2.1.2 AMENDMENT 2: CPW

Additional fresh air intake equipment to CPW level 09 roof

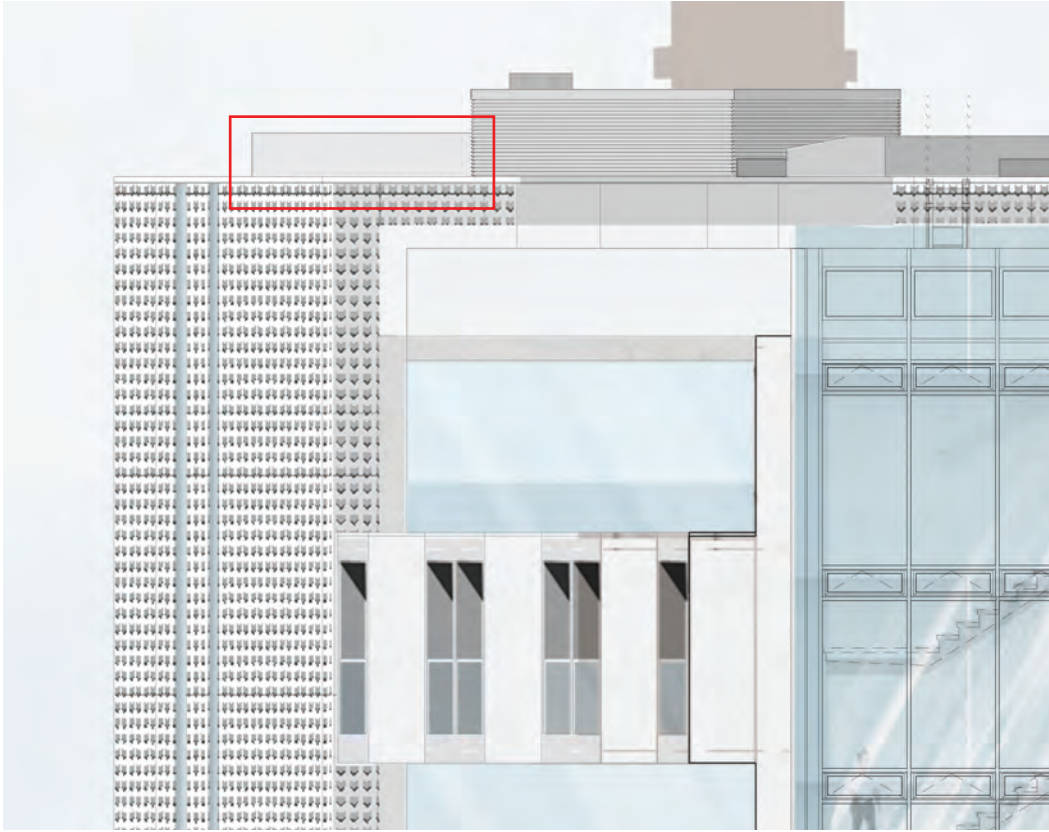
Further detailed design development has demonstrated that, in order to provide sufficient air supply flow rates to the affordable housing apartments, there is a requirement to include additional equipment at the head of their fresh air riser. This comprises a fan unit, including acoustic attenuator, mounted on isolators to the CPW level 09 roof and sitting below the level of the louvred vent housing. The uppermost level of unit will be +58.997 AOD.

APPROVED ELEVATION
Drawing: 19555-CPA North Elevation

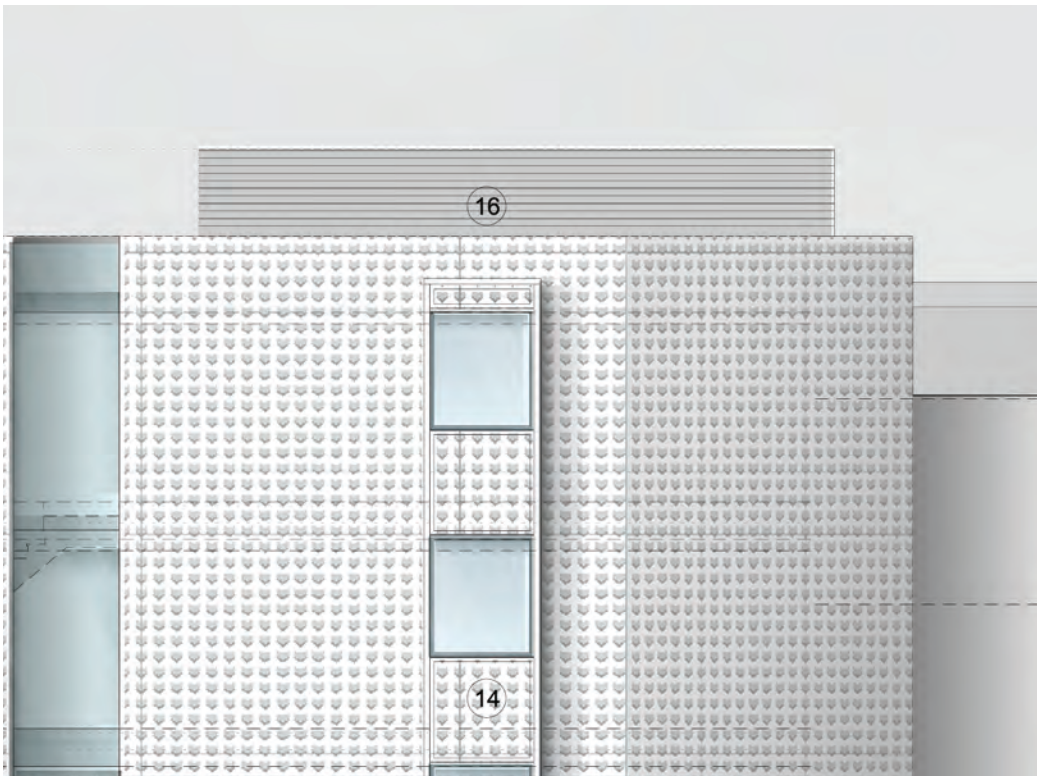
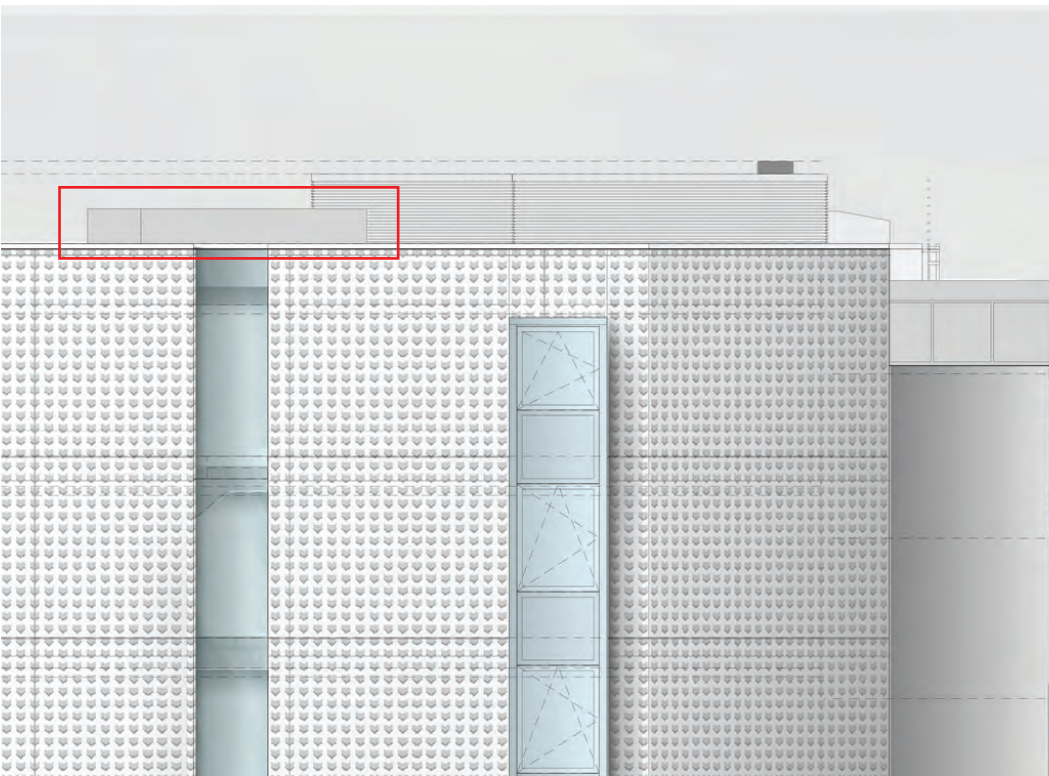
The level 09 roof is considered the optimal location as it provides the cleanest air environment whilst ensuring the equipment is concealed from view below by the surrounding parapets.
